ADDENDUM #1

August 21, 2026

Kevin Ford Aerospace Interpretive Center and Playground Project
Site Package
City of Montpelier, Indiana

Kieser Consulting Group, LLC.
6801 Lake Plaza Drive, Suite D-401
Indianapolis, Indiana 46220

PLAN DATE: 7/28/26		
CHECK: DK	DRAWN: RS	FIELD:
DWG FILE:		
PROJ.-FILE PATH:		
PROJECT NO. N/A		
DRAWING NO. C108

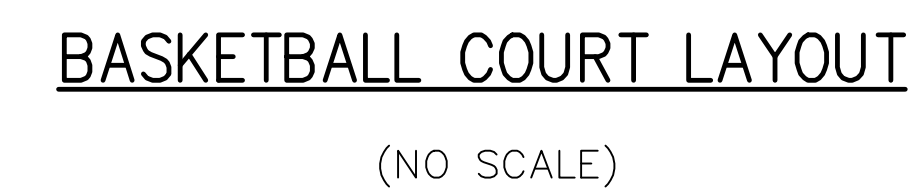
- c. Question 3: Playground aggregate base. I see we are to provide the 4" aggregate base. What size of stone is that to be for the surfacing by the other package?

- a. Sheet C108 – Revised playground curb profile to show 4" of #8 stone beneath the 4" #53 aggregate base. The #8 stone is included in the Site Package; the #53 aggregate base is included in the Playground Package and is a part of the owner supplied materials.
- b. Sheet C109 – Corrected note about bean bag toss area dimensions.

- i. Answer: The 4" #53 aggregate base is included with the Owner-purchased playground surfacing and will be installed as part of the Playground Package. The Site Contractor shall excavate an additional 4" and place and compact 4" of clean #8 stone beneath the #53 aggregate base. The Playground Contractor will install the 4" #53 aggregate base and turf/safety surfacing above the #8 stone. See revised Sheet C108 for the revised playground section.
